PAPERMILL POND DAM

CT. 00471

Review of Non-Federal Dam Inspection Draft Report

NATIONAL PROGRAM OF INSPECTION OF NON-FEDERAL DAMS
DRAFT REPORT REVIEW COMMENTS
PAPERMILL POND DAM, IDENTITY NO. CT 00471
WATER CONTROL BRANCH

D-13

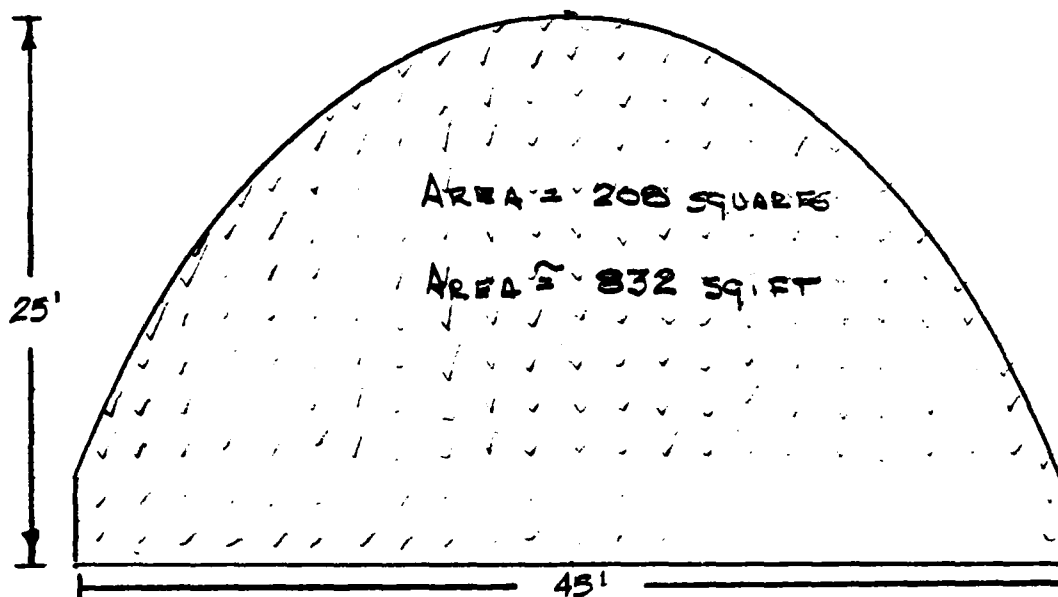
D-13

✓ Can you put a grid on this plate?
